RE: Caliber Collision – 5900 Washington Street, Hollywood, Florida
General Application – Preliminary Technical Advisory Committee (TAC)

RE: Caliber Collision
5900 Washington Street

We respectfully submit the following responses to your comments:

SHEET **C3**

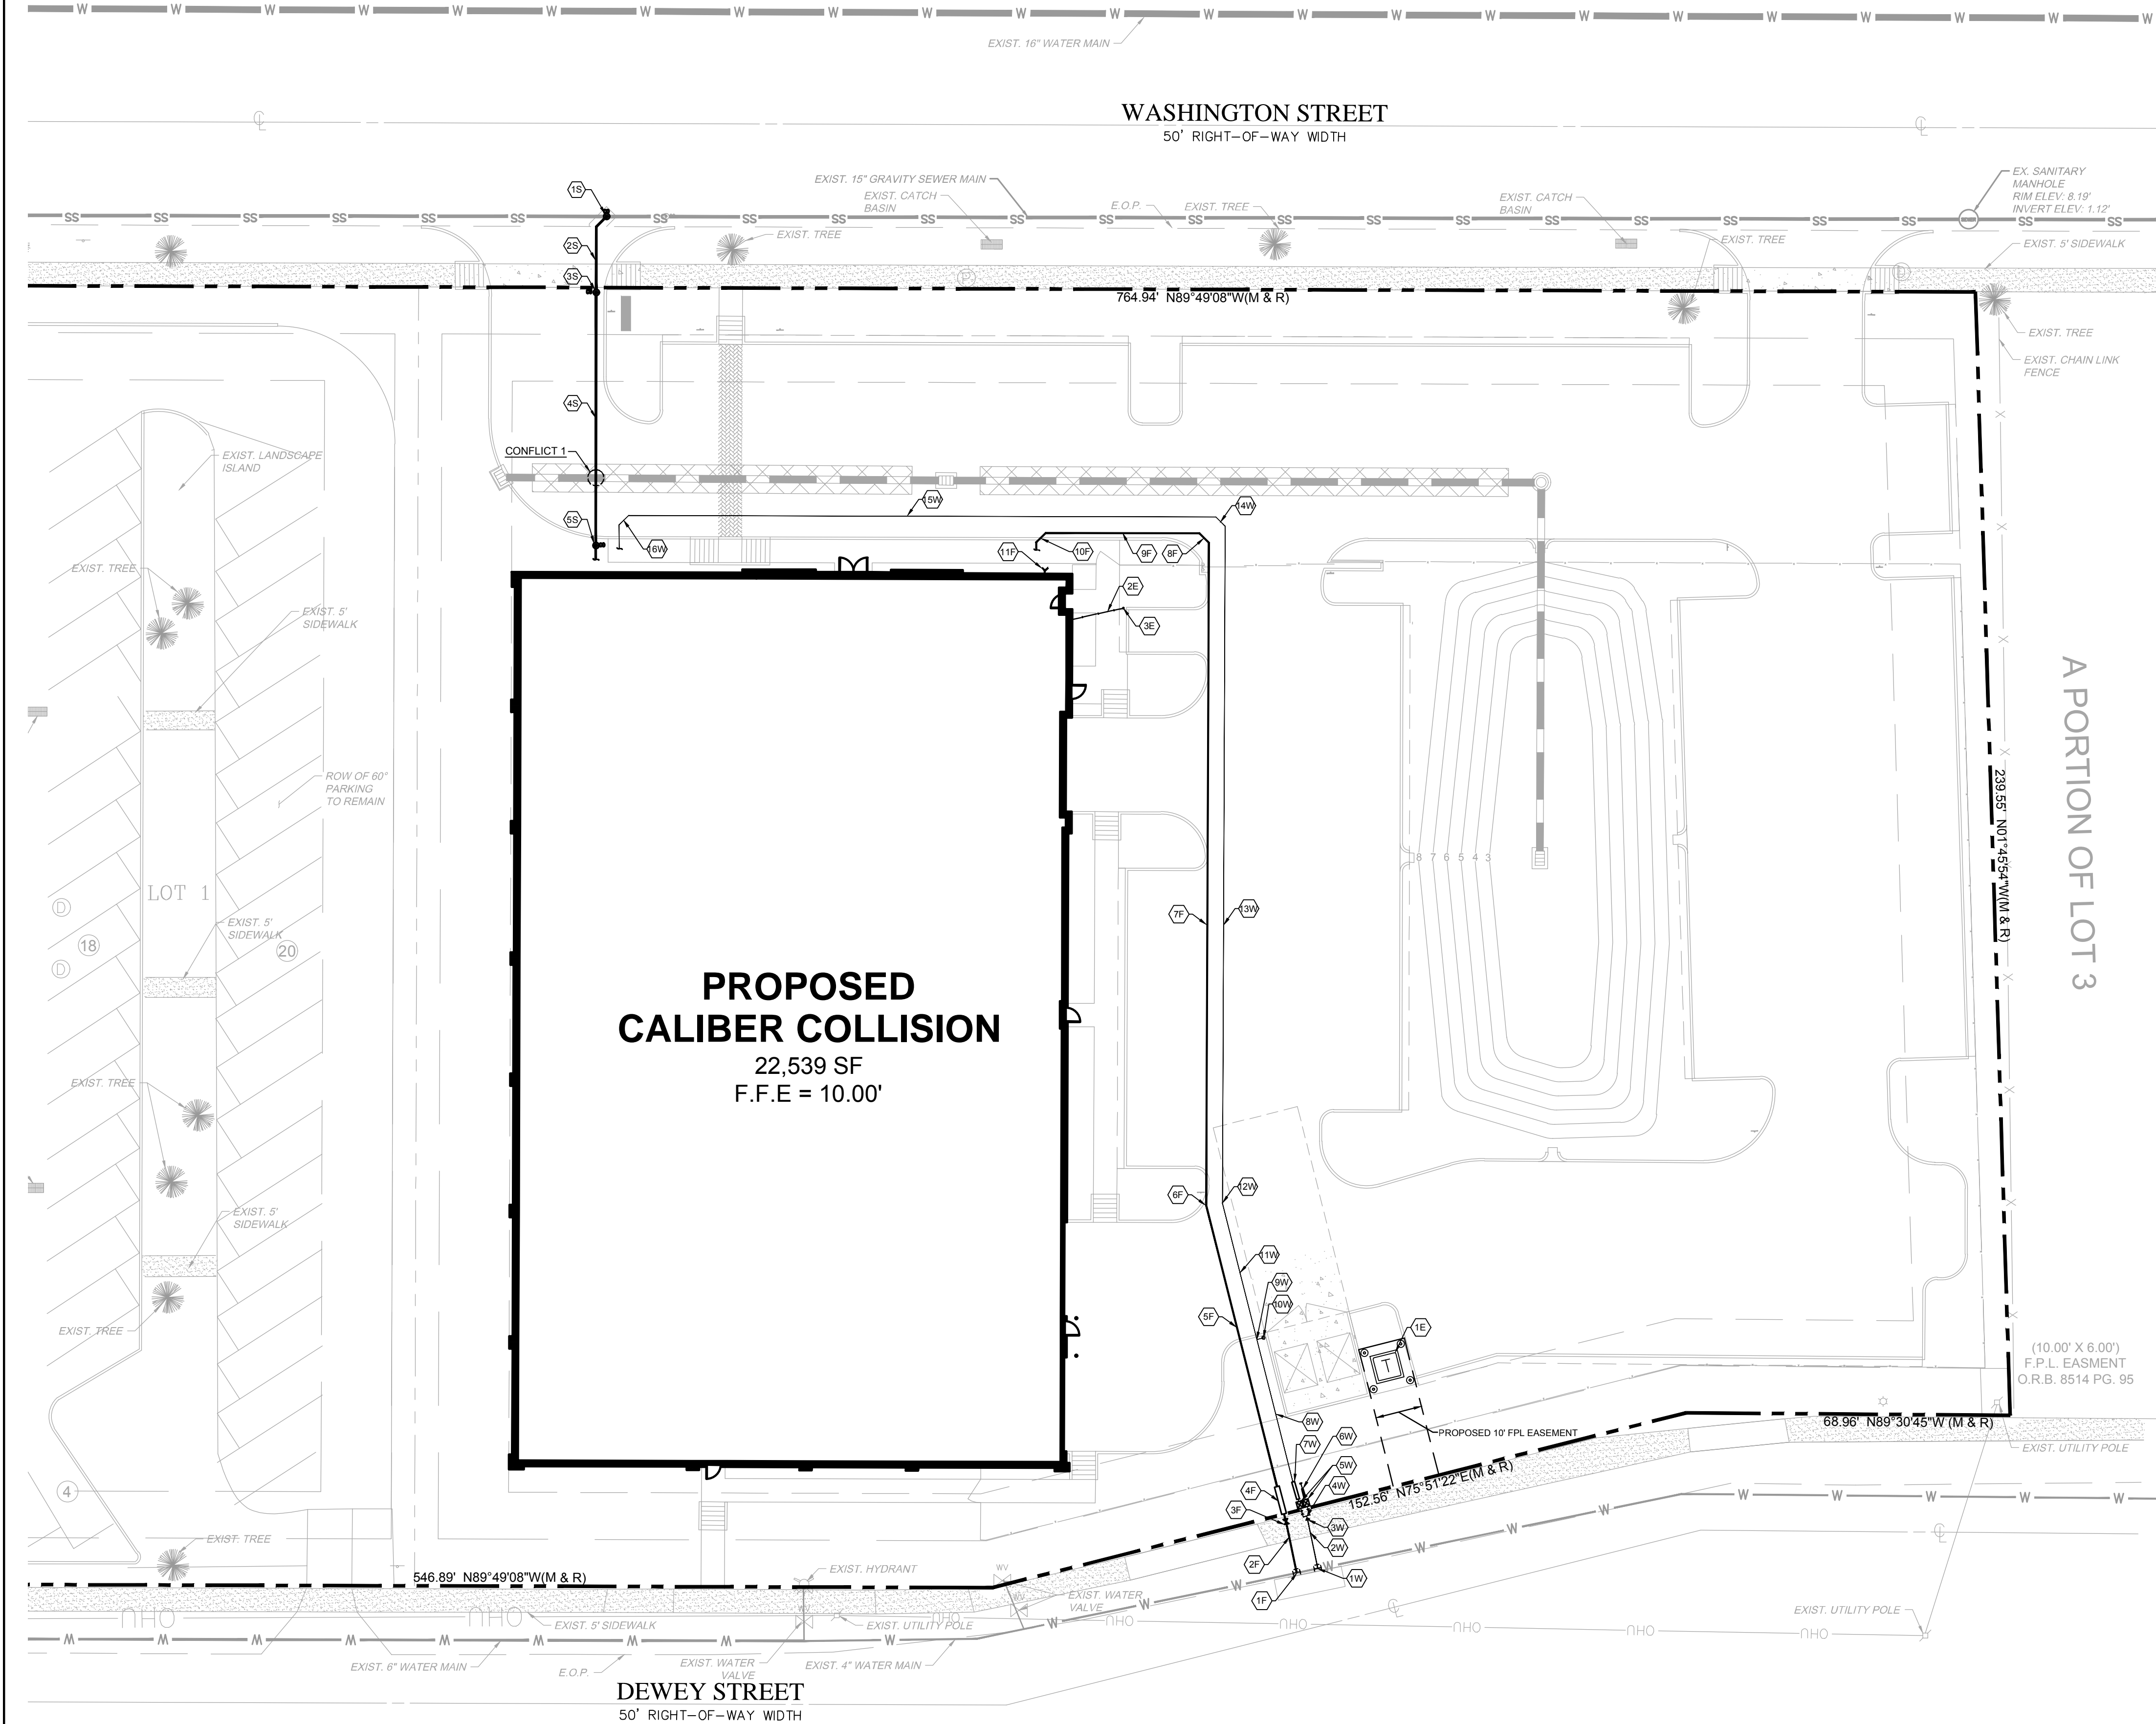
1. Water supply for firefighting purposes shall meet the fire flow requirements found in NFPA 1, chapter 18.4. In order to determine this, a hydrant flow test must be scheduled through underground utilities as 954-921-3046. After test is completed, show the calculations on the plan meeting the requirement of 18.4. If new hydrants are required, show them on the plan. Unable to locate any new or existing hydrants on pg. C-3

2. Provide a note on pg. C-3 that underground fire main work will be completed by a contractor holding a Class I, II, or V license per FS 633.102.

Response: Plan has been revised per your request.

Response: A note has been added.

1 FLOOR PLAN
Scale: 1/8" = 1'-0"
NORTH PROJ. N.

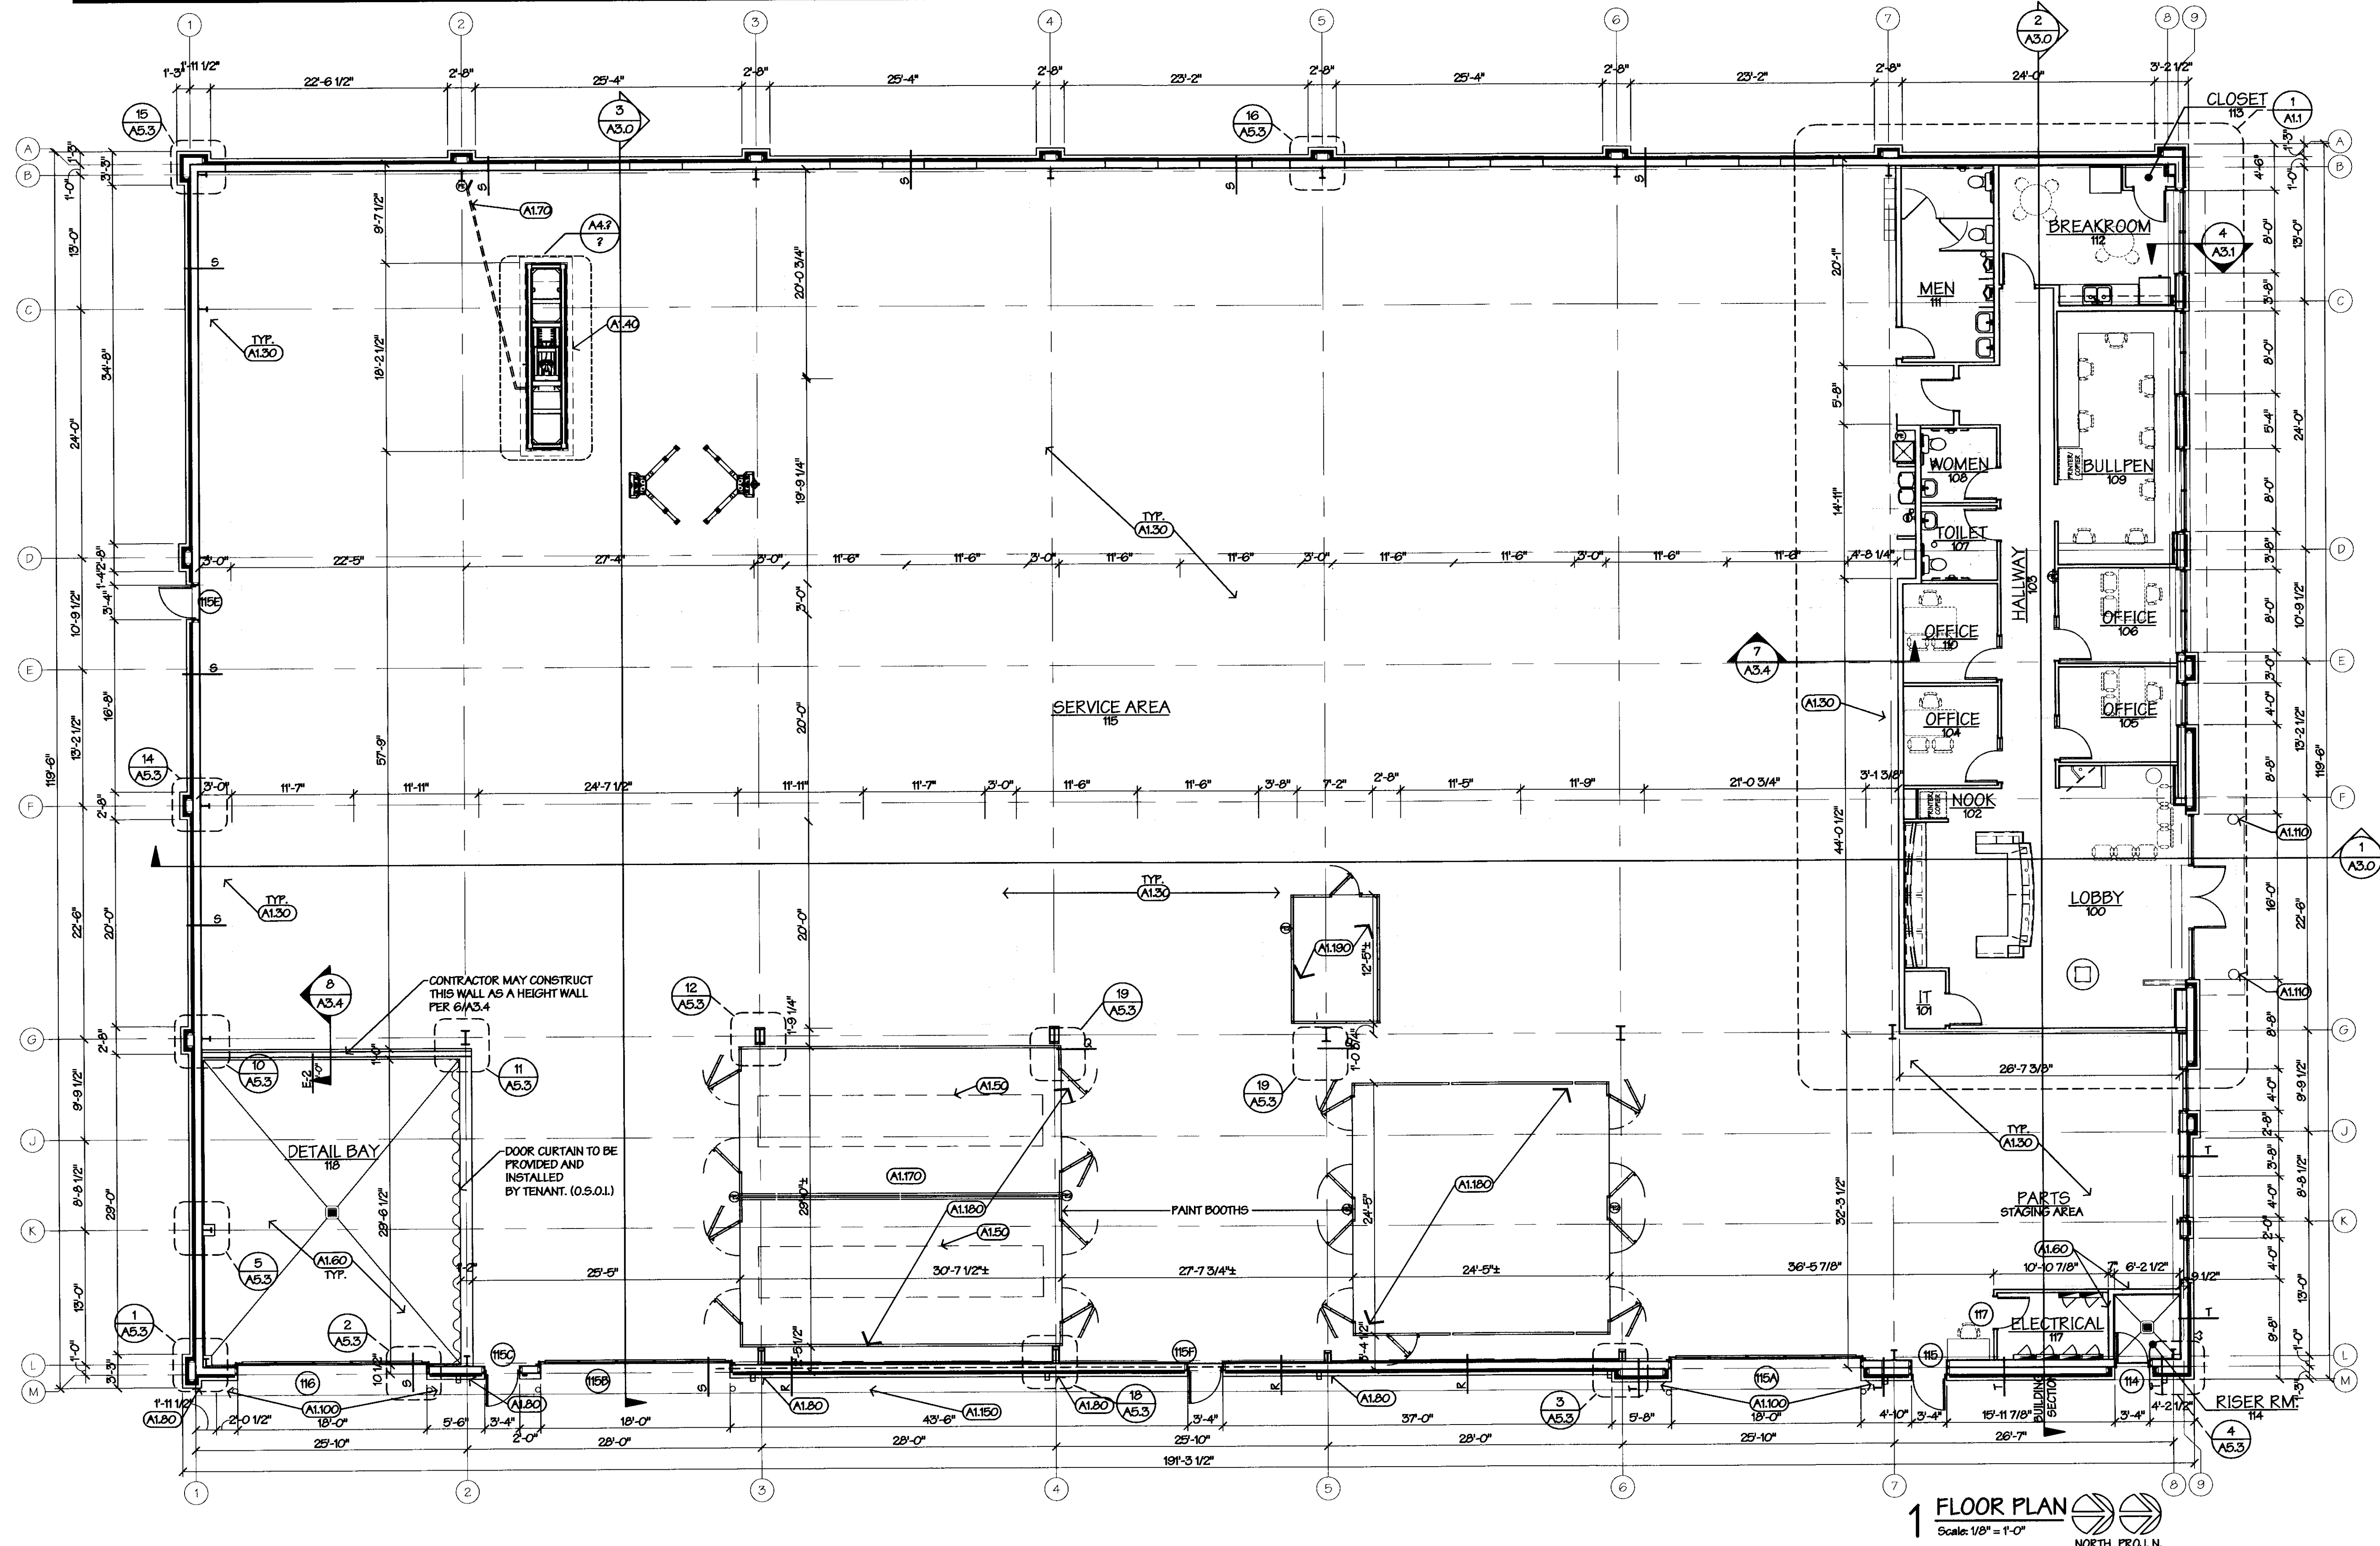
1. Sheet A1.0: The Women's Restroom appears to be too small. At least 50% of the customers will be women. What about the number of employees?

2. Sheet A1.0: Is that a shower or a mop sink out in the Service Area?

3. Sheet A1.0: I only see one floor drain the Detail Bay. What about the rest of the Service Area?

4. Sheet A1.0: Are the Paint Booths mechanically exhausted?

2. Sheet A1.0; What type of activity occurs in “bull pen”? What is the item immediately inside the door to the left? The label is unreadable.

Response: The building code projects that there will be 32 people in the office area and 103 people in the shop area. Code required toilet fixtures based on half being men and the other half being women. This requires 2 commodes (urinals count as commodes) and 1 lavatory for each gender. The requirement for men is more than satisfied by the large toilet off the shop. We have 2 smaller toilets in the office area. One is marked women and one is marked as a family/assisted toilet. Code allows the family toilet fixtures to satisfy the required women's fixture count. Therefore the building code is satisfied as shown.

Response: That is a mop sink in the Service Area.

Response: We are showing only one floor drain in the Detail Bay. There are no drains indicated in the service bays or drive aisles. The Detail Bay is the only place where cars are washed.

Response: The two down flow paint booths both have a 34" diameter exhaust and 34" fresh air supply through the roof with terminations. The prep booth has 34" diameter exhaust and supply air vents through the roof with their terminations. The mix room has a 10" exhaust through the roof. All of the roof top equipment is to be hidden behind a fascia.

Response: Insurance agent temporary office space.
